#### PLANNING COMMISION MINUTES

#### APRIL 19, 2022

To: City of Chelsea Planning Commission From: Julia Upfal, Community Development Director, City of Chelsea Subject: Combined Preliminary and Final Site Plan- Heydlauff's Expansion Date: April 16, 2022

This letter is to provide feedback on the 4 plan sheets and 5 architectural plan sheets submitted to the City of Chelsea for the expansion of Heydlauff's showroom, including a 592 SF building addition, located at 107, 107.5, 109, and 113 N. Main Street, Chelsea, Michigan 48118. The Planning Commission shall review these plans with consideration of the following comments from the Planning and Zoning Administrator.

•

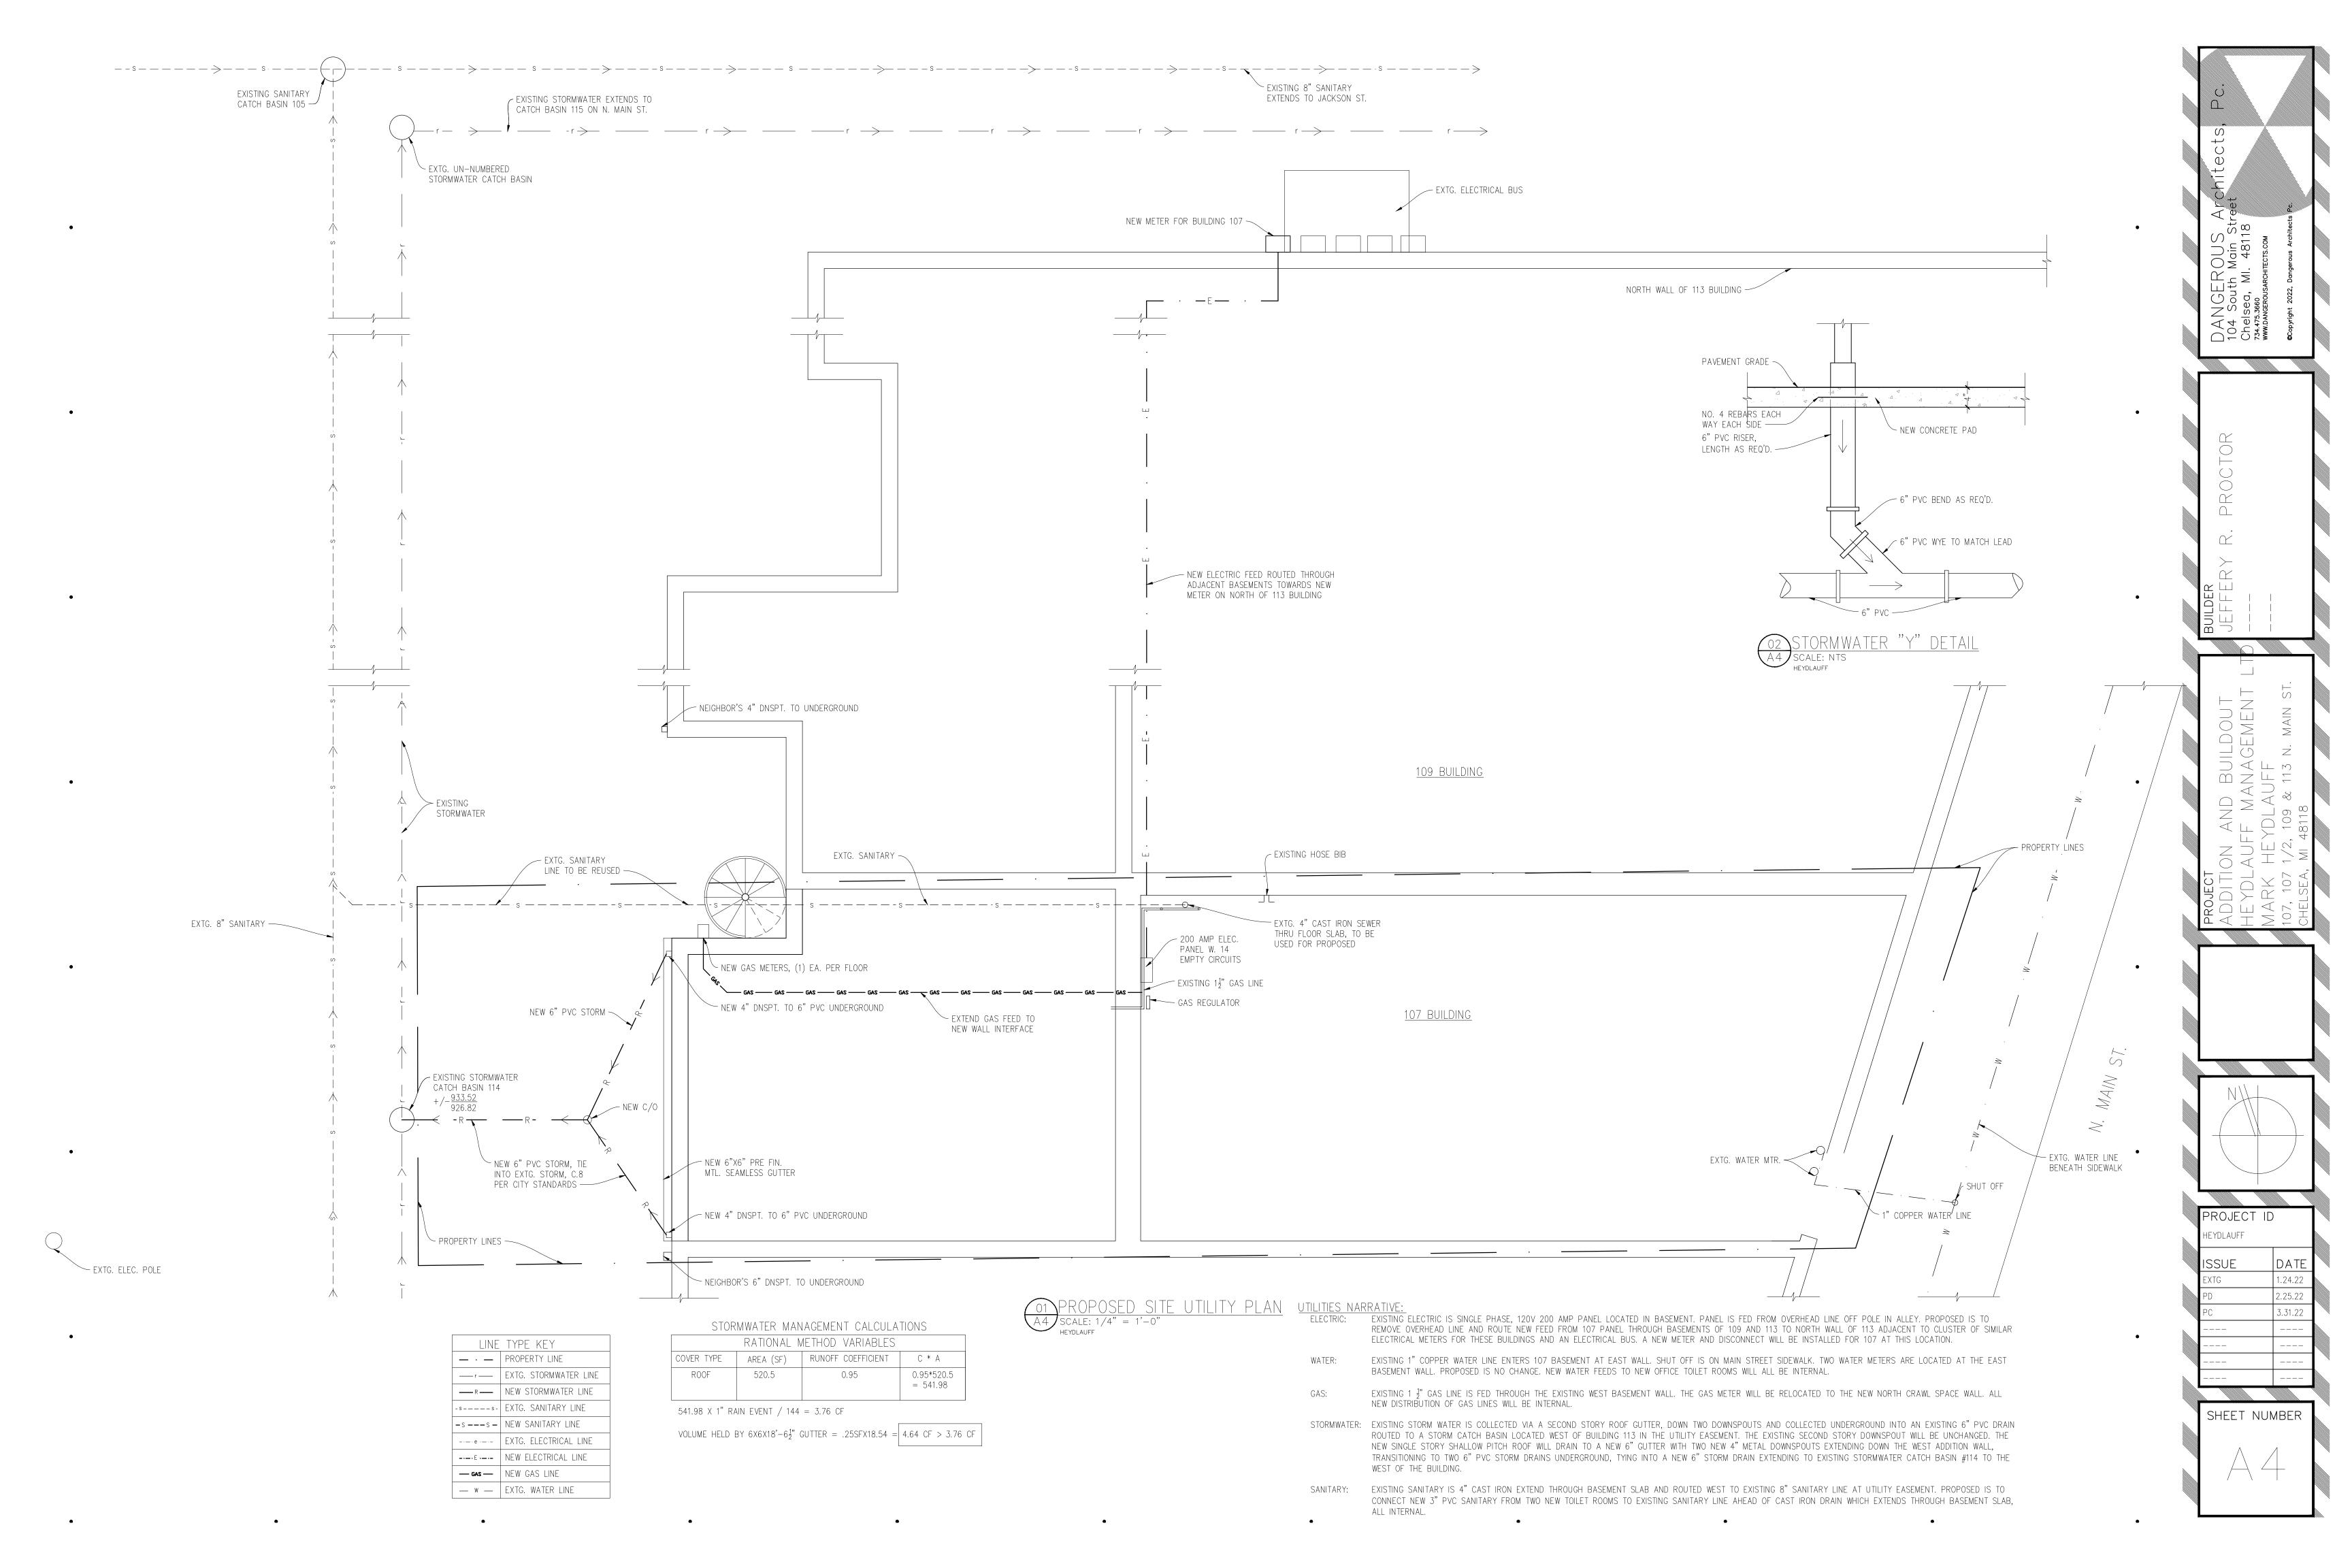
- 3. On Sheet A2, the applicant includes a waiver request for a reduction in first floor rear façade windows. The Planning Commission shall review this request, consistent with Article 5.03.

- 5. On Sheet A2, the applicant should include a note which explains whether new brick will match existing, consistent with Article 5.06 A-2 "Unified Storefront Design."

- 9. On Sheet A2, the applicant includes waiver requests for front façade windows, however, the proposed windows have the same level of compliance as what as previously there. Therefore, a waiver request is not required and this note should be removed.

- a. We recognize the Planning Commission's input and believe that the new addition is compatible with the existing building and the ordinance.
- 11. Windows on the rear façade shall be recessed into the façade wall to appear as though they were "punched" through the building façade (5.07 F-11)

13. Awning details should be provided to show compliance with Article 5.08C.

- a. This note has been removed from the front façade second floor windows.
- 10. The Planning Commission shall provide feedback on whether the proposed spiral staircase and guardrail are compatible with the existing building (5.07F-12).

- a. New rear windows will comply with this ordinance requirement and a note has been added to Sheet A2. A typical window detail used for both historic and new construction is the window frame extends onto the 4" brick by 1", meaning the outer edge of window frame is

3" in back of the outer brick plane which will provide the nonflush/punched look.

- a. The previously approved awning from 109 N. Main will be visually extended across the 107 N. Main building with a new awning to match 109 N. Main. Awning details are provided on drawing 05 on sheet A2.
- 14. Soil Erosion and Sedimentation Control Plan must be approved by the Chelsea Area Construction Agency as a condition of approval.
  - a. We recognize that soil and erosion control must be approved by others. Please see 01/A3.
- 15. The applicant modified their draining plan to connect to an existing 6" drain in the rear of the building. The Department of Public Works is concerned this 6"
